Access Compliance Report

Public Rights-of-Way (Curb Ramps)

Intersection ID: 23691	Main Street: BALTUSROL_LN	Cross Street: N/A	Location: SE
ADA ID: C038CE359937	Ramp Type: PerpDiag	Initial Pass/Fail: Fail	Overall Compliance: No
Severity Score: 8.75			
Codes/Mitigation Info/Possible Solution		Field Measurements/Component Compliance

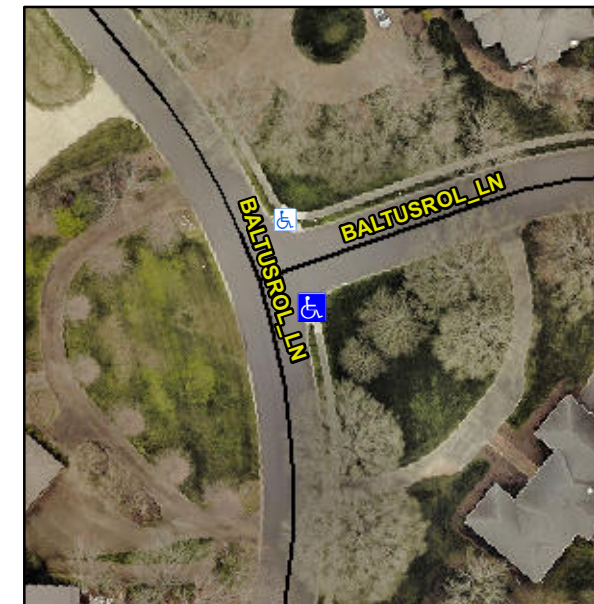
Not Found, R304.5.1

Compliance	Description	Data	Compliance	Description	Data
N/A	Ramp Length (in)	67.0	Yes	Ramp Slope (%)	5.9
No	Ramp Width (in)	47.0	Yes	Ramp XSlope (%)	1.3
N/A	Flare Type LT	N/A	N/A	Flare Type RT	N/A
N/A	Flare Slope LT (%)	N/A	N/A	Flare Slope RT (%)	N/A
N/A	Flare Traversable LT?	N/A	N/A	Flare Traversable RT?	N/A
N/A	Landing Length (in)	N/A	N/A	DWS Provided?	N/A
N/A	Landing Width (in)	N/A	N/A	DWS Contrast?	N/A
N/A	Landing Slope (%)	N/A	N/A	DWS Length (in)	N/A
N/A	Landing X Slope (%)	N/A	N/A	DWS Full Width?	N/A
N/A	Landing Curb? (Y/N)	N/A	N/A	DWS Offset (in)	N/A
N/A	Shared Landing?	N/A			
N/A	Gutter Ponding?	N/A	N/A	Gutter Slope (%)	N/A
N/A	Gutter Lip Ht (in)	N/A	N/A	Gutter X Slope (%)	N/A
N/A	Painted X Walk1?	No	N/A	Painted X Walk2?	No
	X Walk 1 Direction	To N		X Walk 2 Direction	To W
N/A	X Walk 1 Width (in)	N/A	N/A	X Walk 2 Width (in)	N/A
	X Walk 1 Slope (%)	4.0		X Walk 2 Slope (%)	2.1
	X Walk 1 X Slope (%)	2.2		X Walk 2 X Slope (%)	4.2

Remove & Replace Curb Ramp With Two New Directional Ramps or Equivalent.
